GIGAFLIGHT
CONNECTIVITY INC.

DESCRIPTION:
HD D-SUB 26 MALE W/FEMALE SCREW LOCKS TO DVI-D MALE W/THUMB SCREWS

CAGE CODE: 8A8D5 DRAWING NUMBER: GFAHDMI-401 SHEET: 1 OF 2

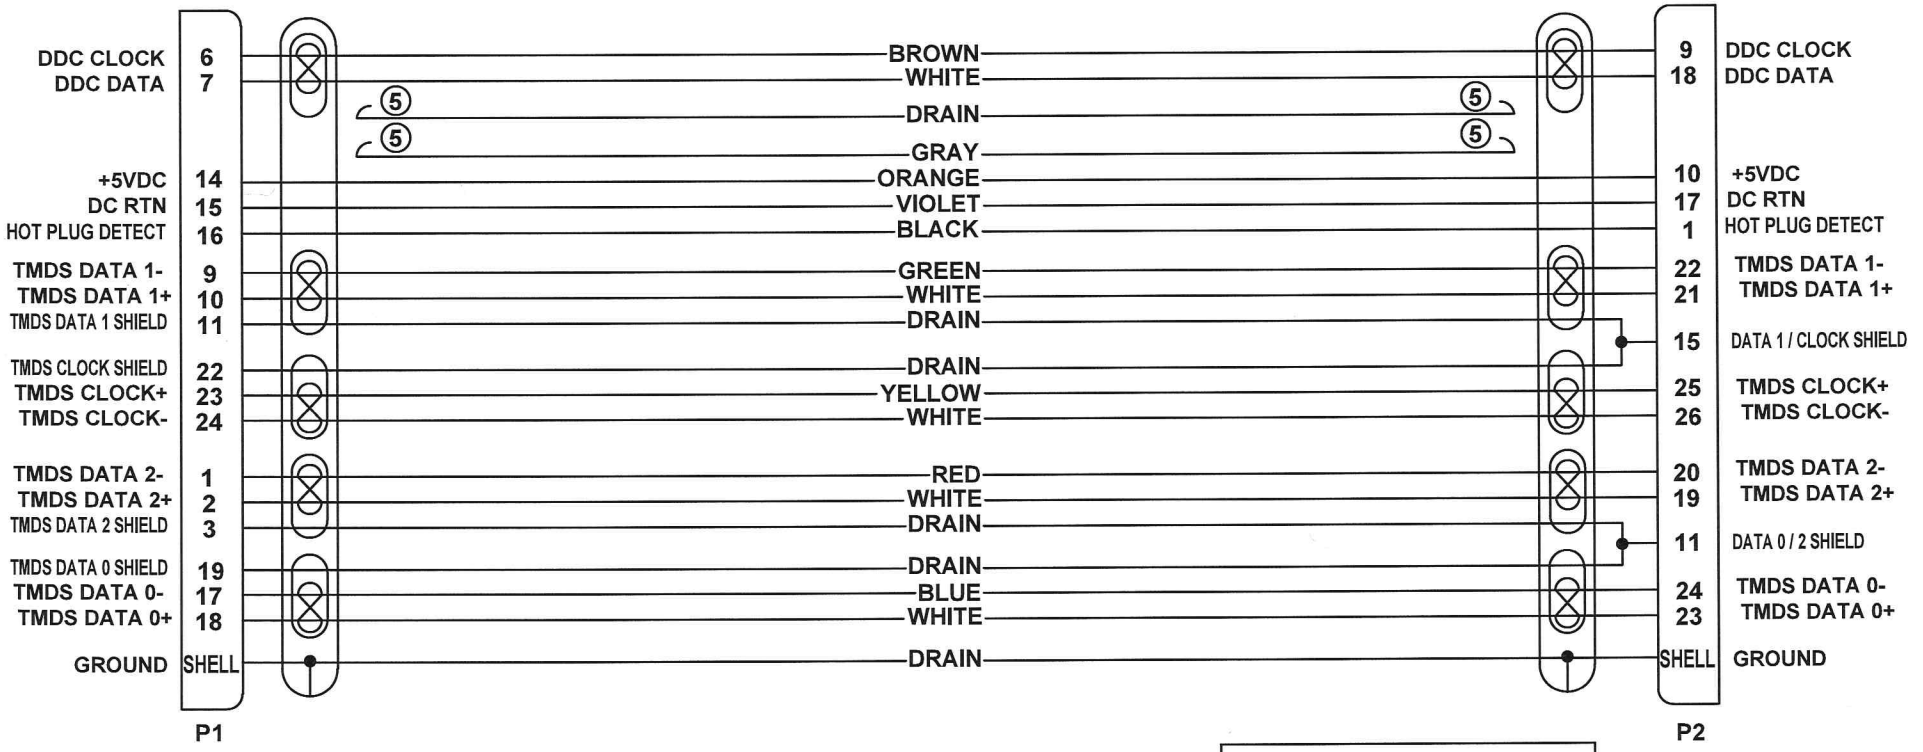
ECN	REVISION	ZONE	SHEET	DESCRIPTION OF CHANGE	APPROVED	DATE
613	NR	-	-	INITIAL RELEASE	KMK	9/21/22
947	A	P/L A2/D2/D5	1 2	UPDATE QTY OF ITEM 8 FROM 6 TO 4.5. ADD MATERIAL ATUM-16/4-0 QTY 1.5. ADD ITEM 15 TO THE LEFT SIDE OF THE DRAWING AND DELETE 18 ON THE UNUSED D-SUB CONTACTS PORTION	TF	6/21/24
